<p>Invitation for Bids Amendment #2</p>	Solicitation Number	TCTC-22-Wilson RTU's
	Date Issued	5/12/2022
	Procurement Officer	Matt Whitten
	Phone	(864) 646-1633
	E-Mail Address	mwhitten@tctc.edu

DESCRIPTION: **This solicitation is for the purchase and installation of 3 HVAC Roof Top Units.**

Amendment #2 – Posted 5/31/2022

TCTC-22-Wilson RTU's  
Notice of Bid Deadline Extension and additional requirements

## RTU-3 CONTROLS SCHEMATIC (SINGLE ZONE CONSTANT VOLUME WITH HOT GAS REHEAT)

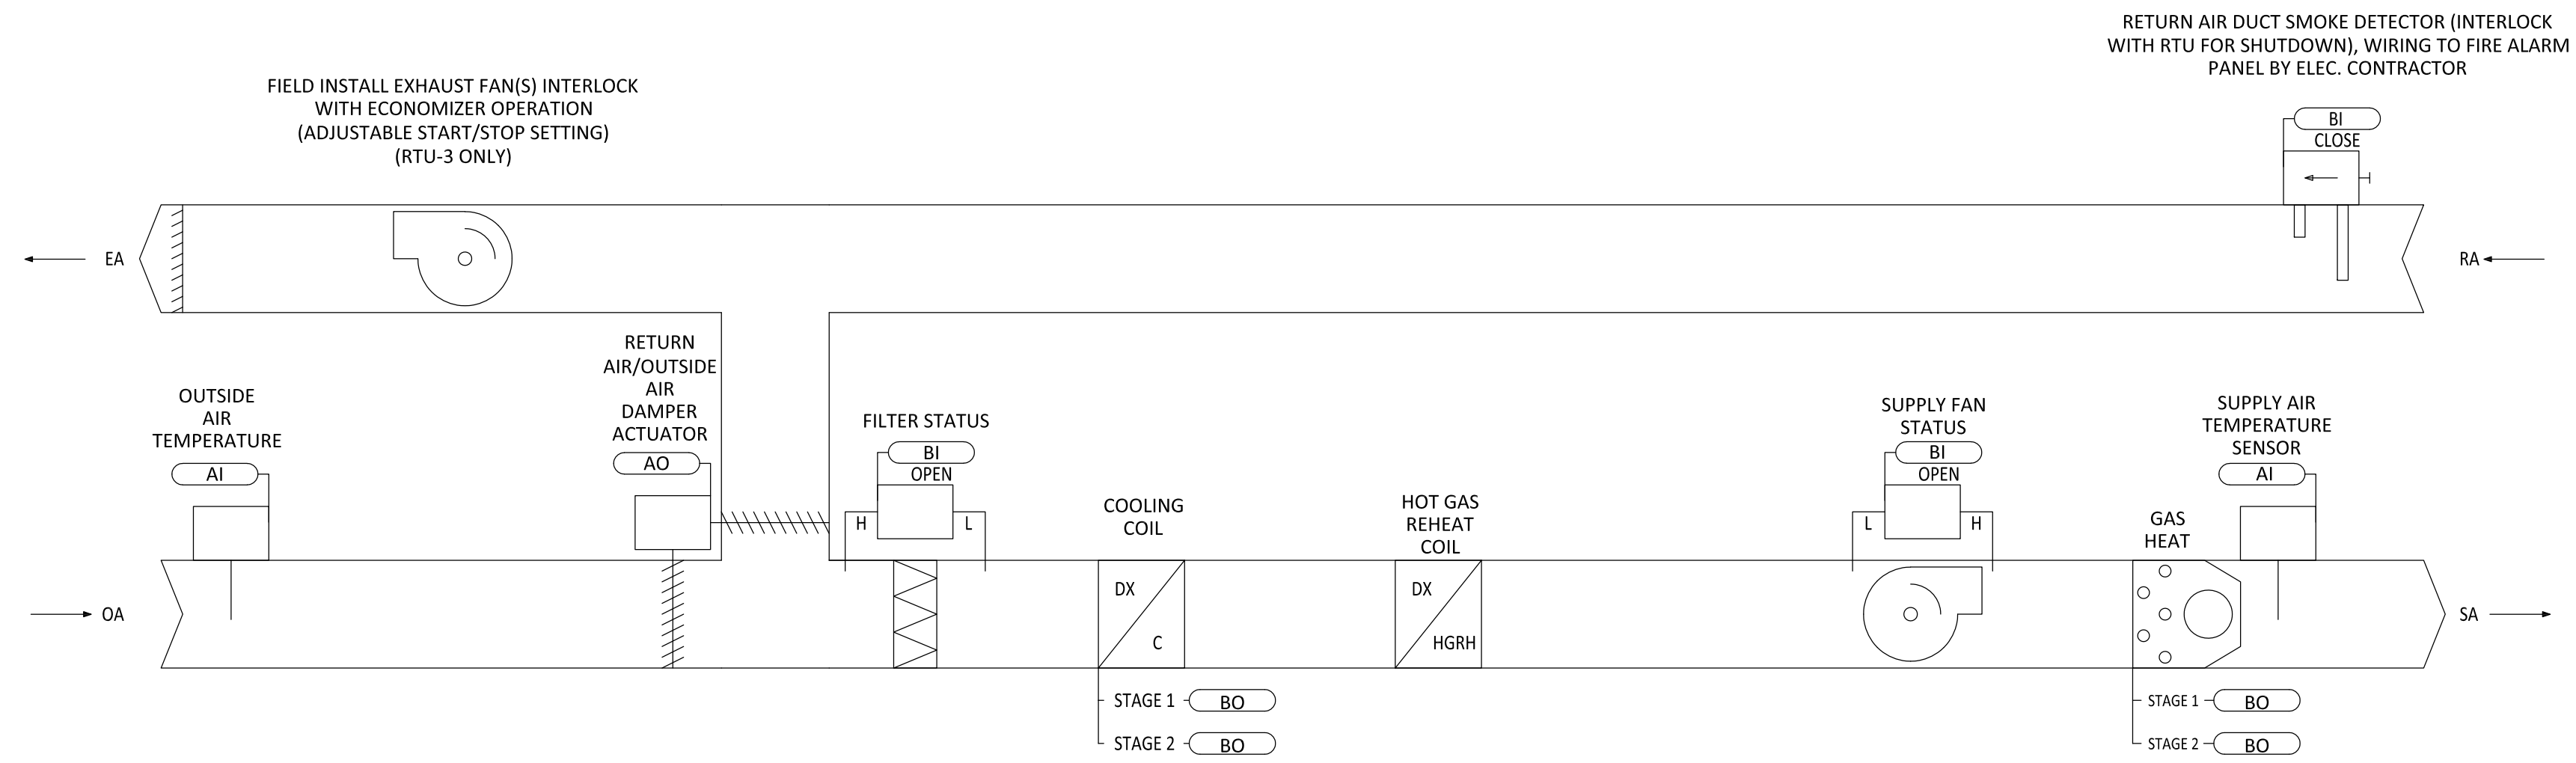
Note that the BAC NET card has been removed from the units and must be connected and interlocked with the existing Automated Logic Building Controls System.

NEW ROOFTOP UNITS SHALL CONNECT AND INTERLOCK TO EXISTING "AUTOMATED LOGIC" BUILDING AUTOMATION SYSTEM, INCLUDING REQUIRED SHUTDOWN INTERLOCK WIRING FROM SMOKE DETECTOR, TEMPERATURE, AND HUMIDITY SENSOR WIRING. IN ADDITION, CONTROLS SUBCONTRACTOR SHALL PROVIDE AND INSTALL "DDC" CONTROLLER, SENSORS, AND END DEVICES OVER-LAYED ON ROOF TOP UNITS TO CONNECT TO EXISTING "AUTOMATED LOGIC" SYSTEM.
